MANDATORY SERVICE

PACSB / XL / 115 ISSUE 3

INSPECTION / REPLACEMENT AILERON PIVOT FORK ASSEMBLY

B. REASON Addition of retaining features to the aileron

FIGURE 1 REMOVAL – FLOOR COVER AND STICK BOOT (TYPICAL)

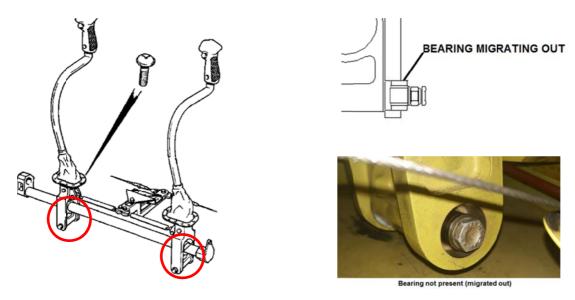
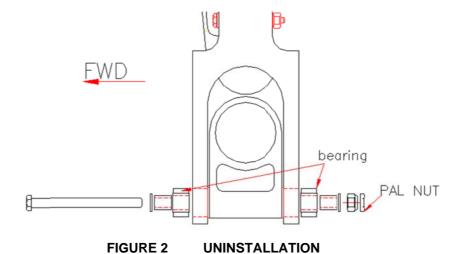
- B.1) Remove the control stick boot and cockpit floor cover (Ref. 750XL MM, Section 27-10-00, Page 401).
- B.2) Uninstall the PAL NUT and the self-locking nut. Carefully remove the bolt. Refer Figure 2. Remove existing hardware.

FIGURE 3 RE INSTALLATION – HARDWARE

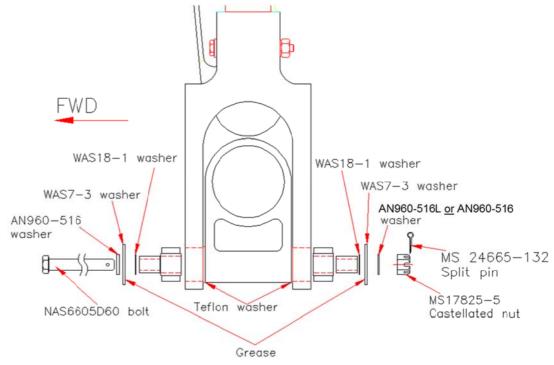
B.3) Re-install the hardware as follows:

a) Open the inner diameter of the P/N AN970-4 washer with a 5/16" drill. (Refer WAS7-3 washer in Figure 3, refer to the attached drawing). The WAS18-1 washers may also be fabricated IAW the attached drawing.

b) Apply AeroShell 22 grease (or any grease product that meet MIL-PRF-81322) to the drilled surface and the inner face of the AN970 washers (See Figure 3).

c) Re-install all parts, according to the sequence shown in Figure 3. Torque nut to 100 - 140 lb.in, before installing the split pin.
